**PARKSIDE VILLAS  
STORM PROFILES  
96-257R2 4/10/98**

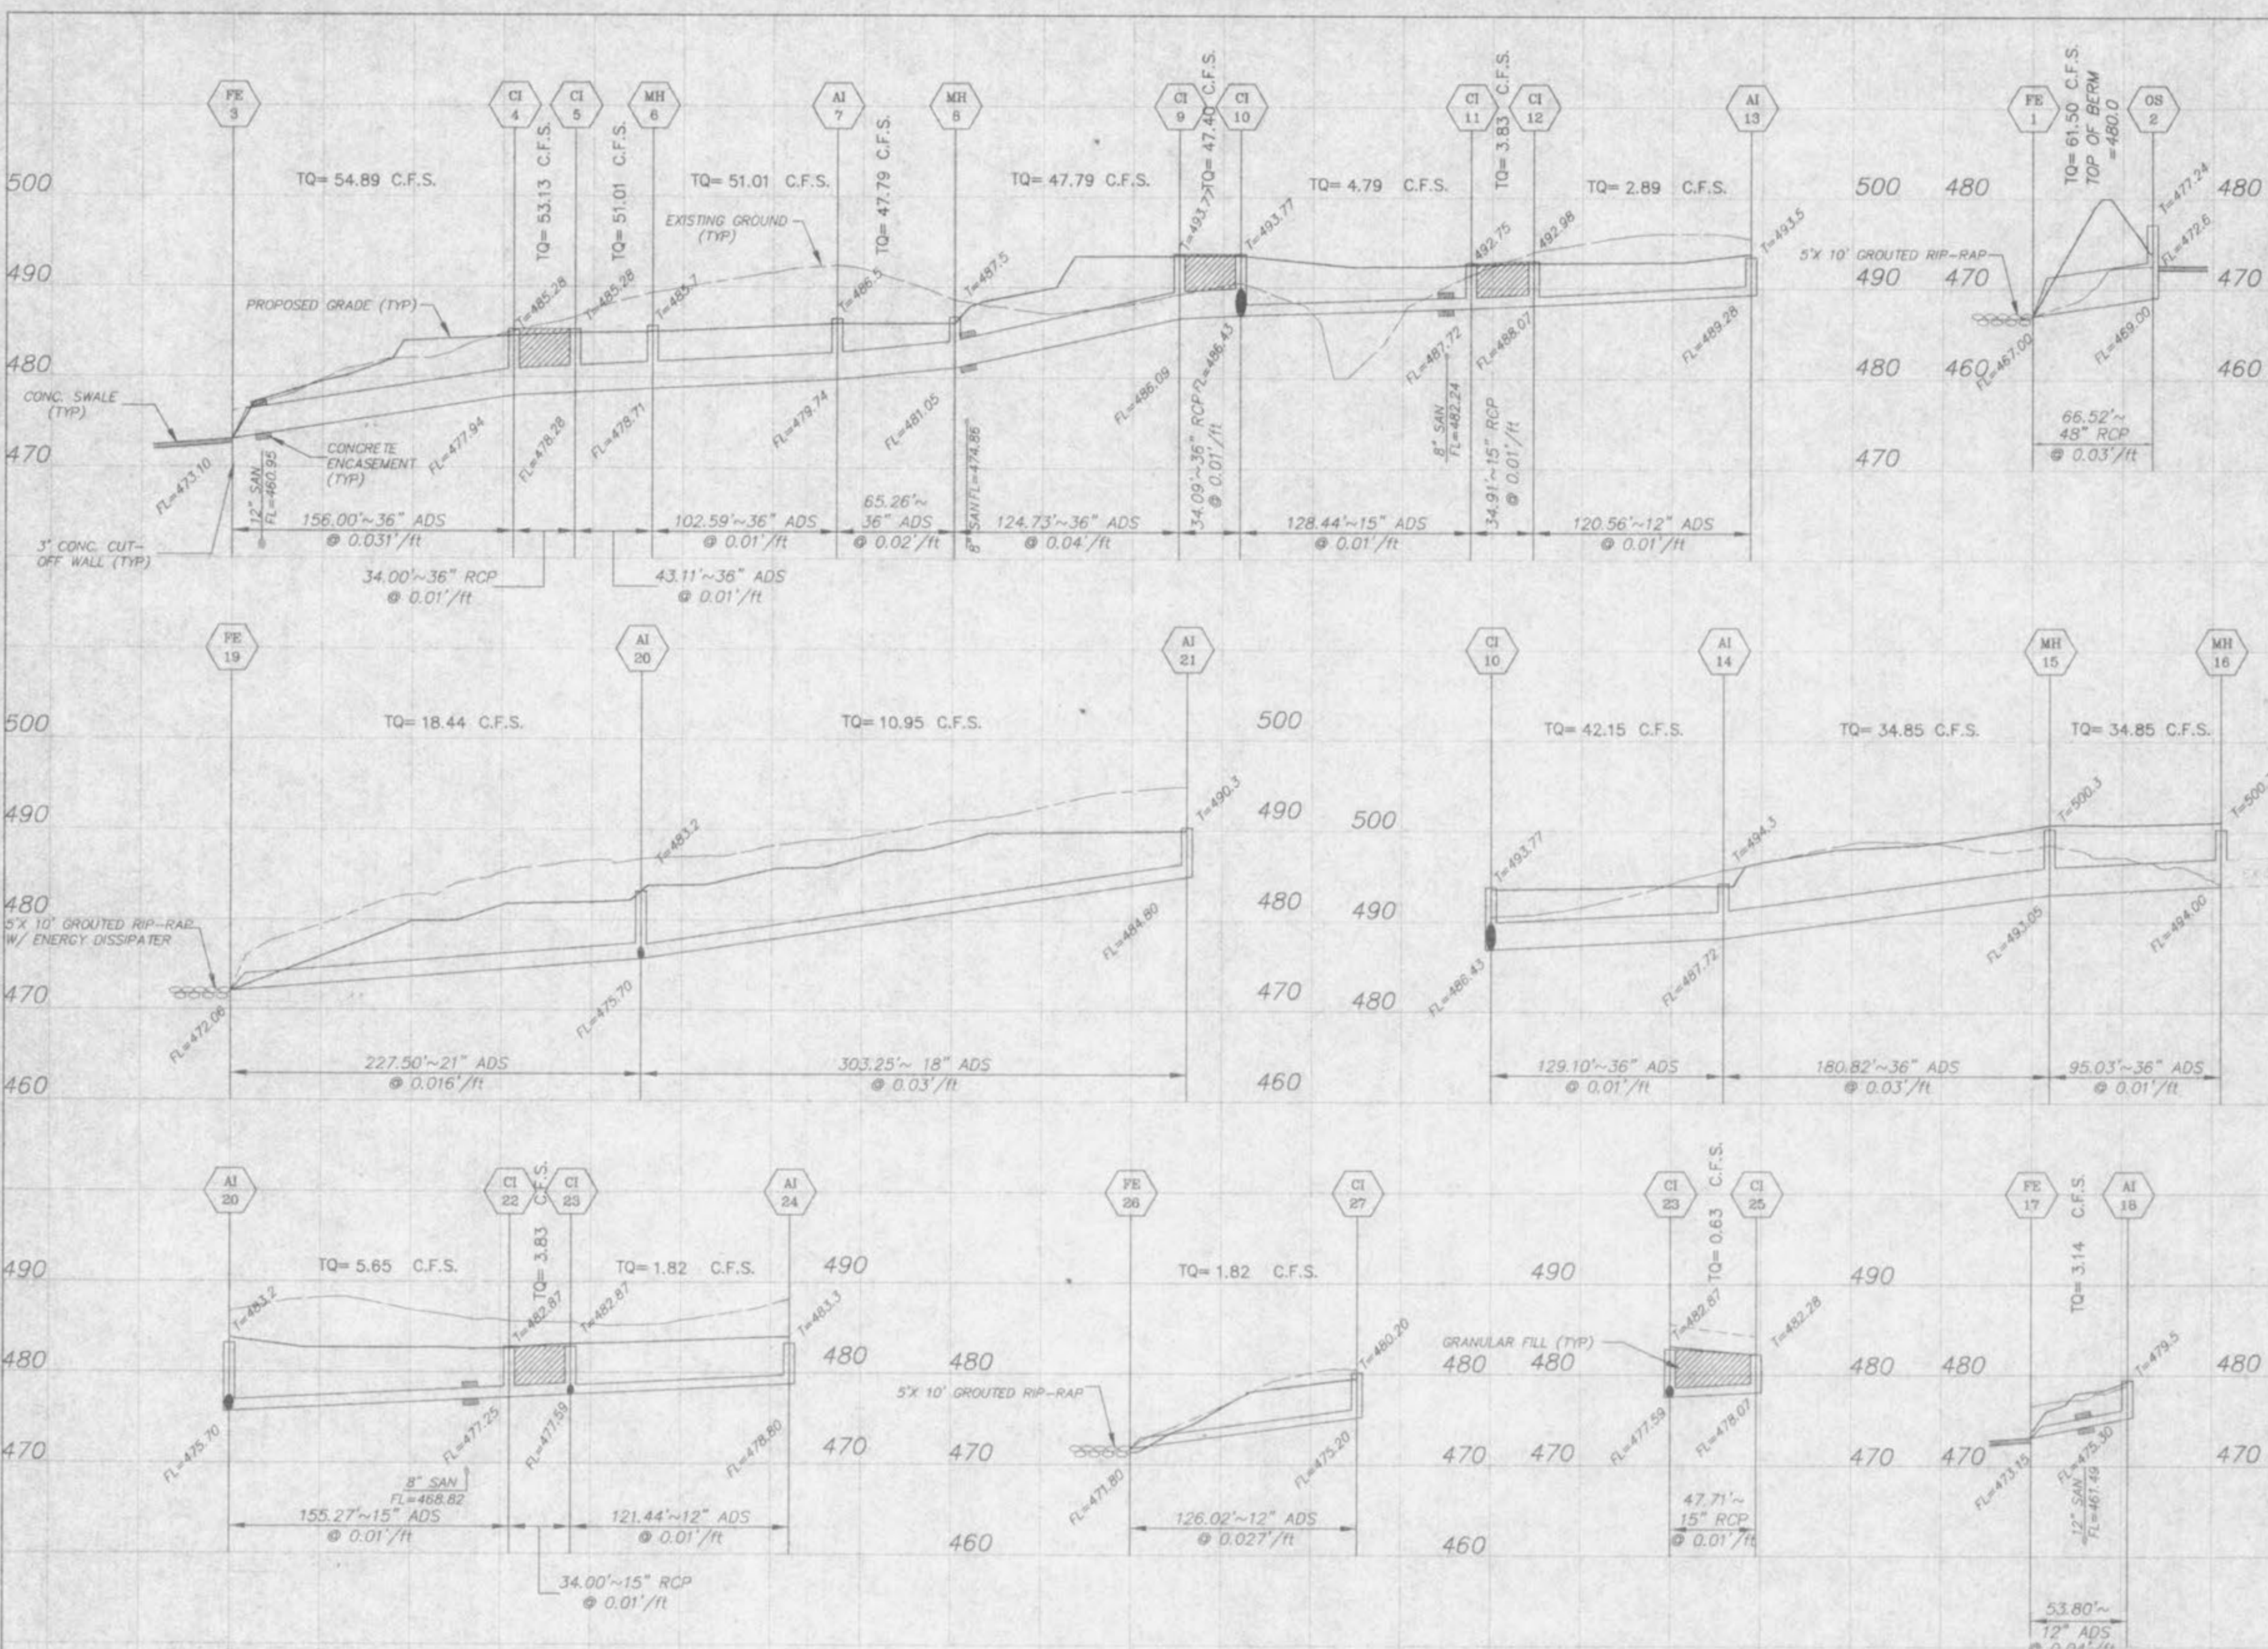
rev UNP per city of Dallas  
rev 2/98 alternative to RCP

All FE to be RCP  
File Copy  
Revised  
**APPROVED**  
6/17/98  
Jean C. Hill
